Subject: Issuance of Approved Version of WCAP-12472-P-A, Addendum 2-A/WCAP-12473-A, Addendum 2-A of "BEACON Core Monitoring and Operation Support System," (Proprietary / Non-proprietary)

BEACON
Core Monitoring and
Operation Support System

WCAP-12473-A
Addendum 2-A

By letter dated March 29, 2001, Westinghouse submitted WCAP-12472-P-A, Addendum 2, "BEACON-Core Monitoring and Operations Support System," for staff review and approval. The main topical report (TR) was approved by the staff on February 16, 1994. Addendum 2 extends the previously licensed BEACON power distribution monitoring methodology to plants containing platinum self-powered fixed incore detectors and Vanadium self-powered fixed incore detectors.

Figure 2
Platinum
Standard Deviation of Prediction to Measurement Errors

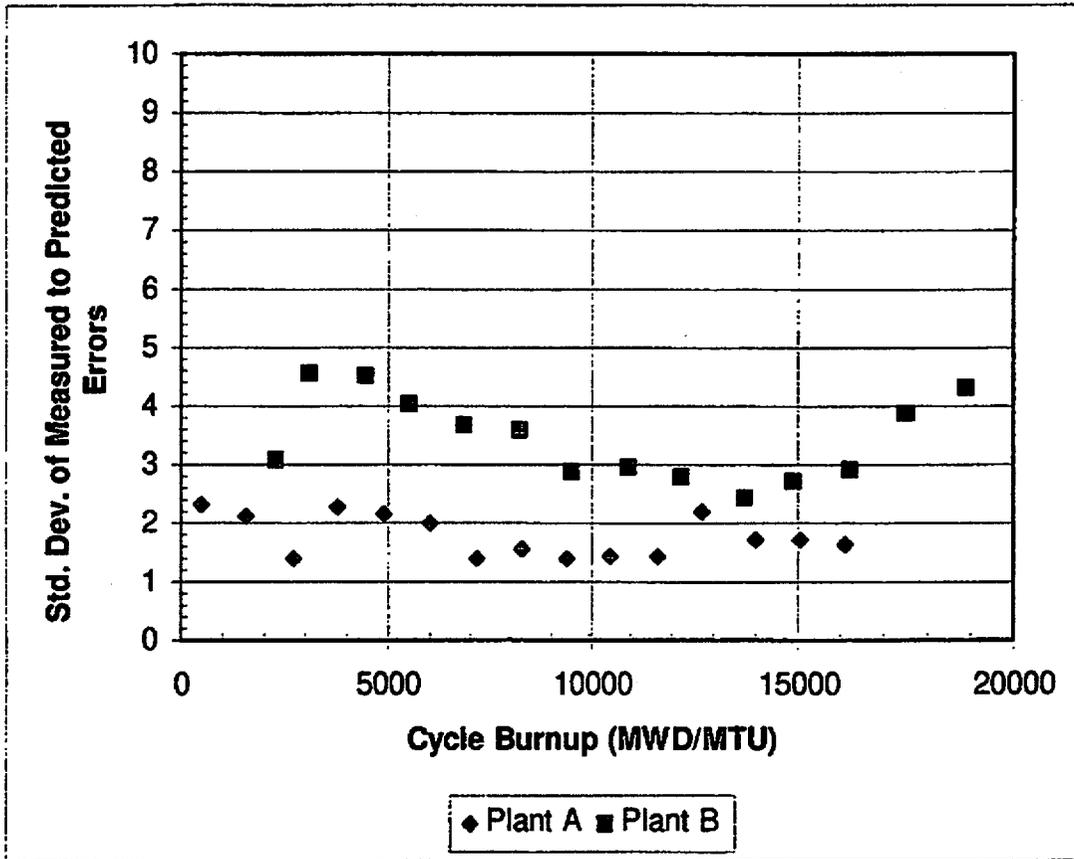
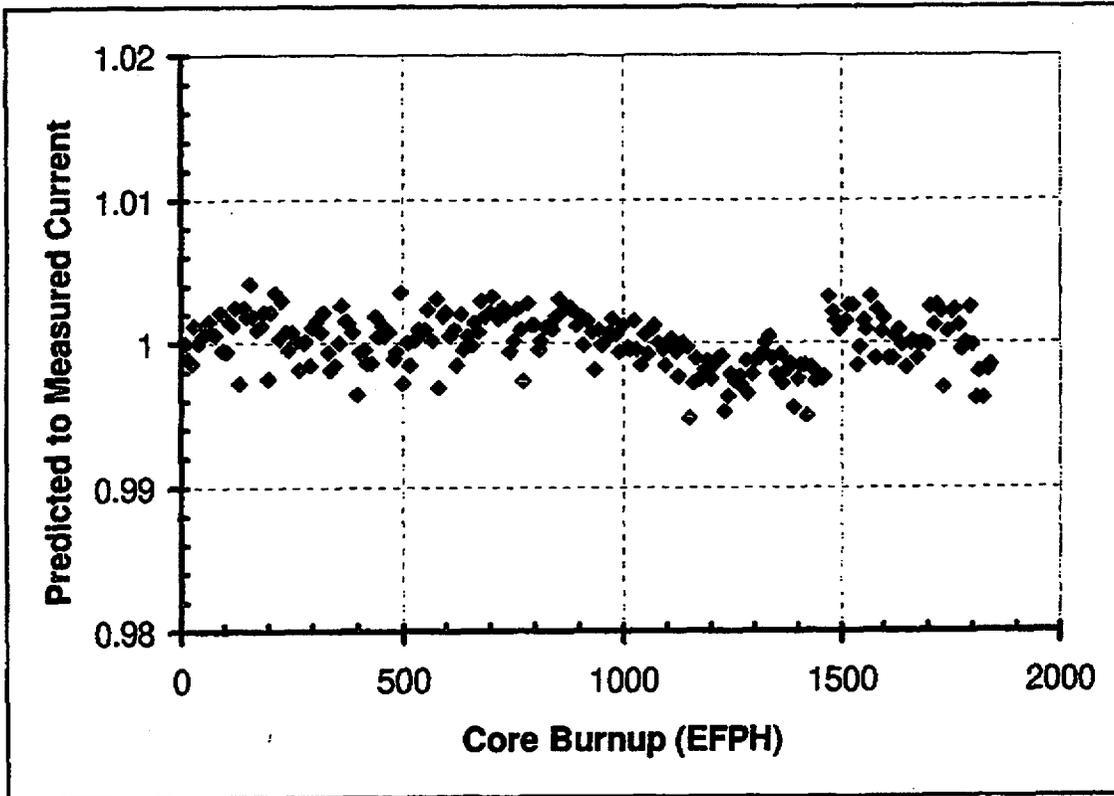
14. Figures two and three provide some insight into the uncertainties associated with the Platinum and Vanadium detectors. However, no data was provided as to the uncertainties associated with the "combined uncertainties" associated with the case of having Rhodium, Vanadium, and Platinum detectors in the same core. Please provide statistics associated with different combined configurations. i.e., measurability uncertainty, standard deviations, etc., etc.

Response: While the BEACON methodology would permit assembly by assembly (or more appropriately, detector by detector) variabilities, this methodology is not currently used. For mixed cores, the variability is determined for each detector type. At this time, the overall variability used in BEACON is conservatively based on bounding the maximum variability for all the detector types. This can be changed in the future to apply the variability and resulting uncertainty by detector.

Figure 4
Platinum
Axial Detector Location

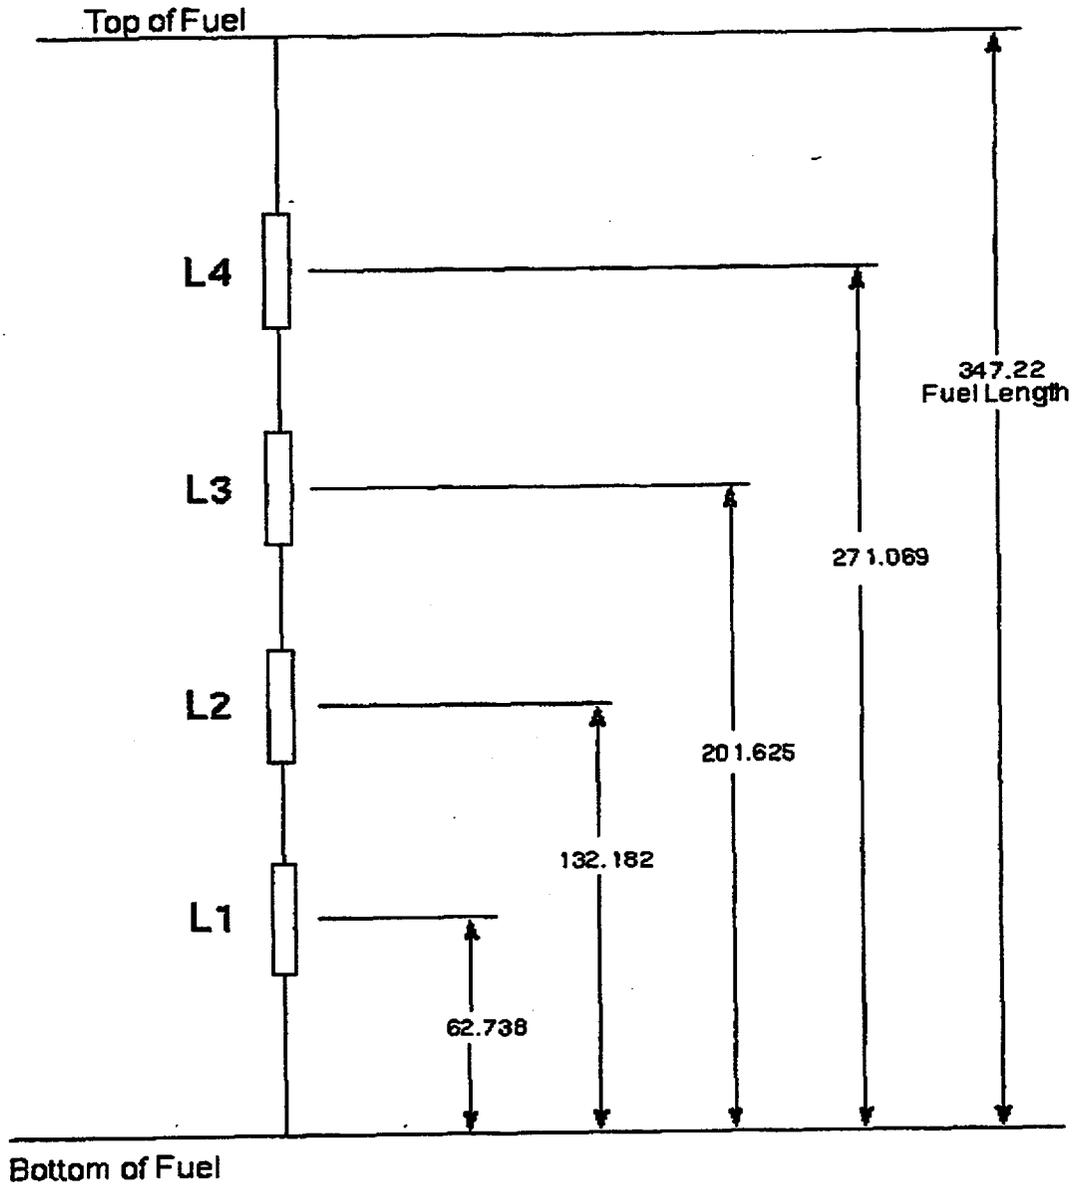
3. Figure Four shows that the Platinum detectors are arranged with four detectors in a string. It is not clear from Figure Five how the Vanadium detectors are arranged.

Response: The detectors are as illustrated in Figure 5 of Addendum 2. The detectors are of unequal lengths. The first detector is a full-length detector covering the entire core. The second detector is 80% of full length; the third detector is 60%, and so on. Individual axial segment measurements are obtained by subtracting the currents of each successive detector. This configuration has several benefits for fixed incore detectors. First, since the vanadium current is lower than Rhodium, this longer detector configuration gives a stronger signal. Because there is no exposed lead wires in this configuration, no background wire is required, meaning no manipulation of background data is required. Finally because no background wire is used, the connector for the background wire can be used to add an additional detector. Therefore a plant that had only 4 Rhodium detectors in a string can increase the number of detectors to 5 with the Vanadium design, thus improving the axial resolution of the measurement.
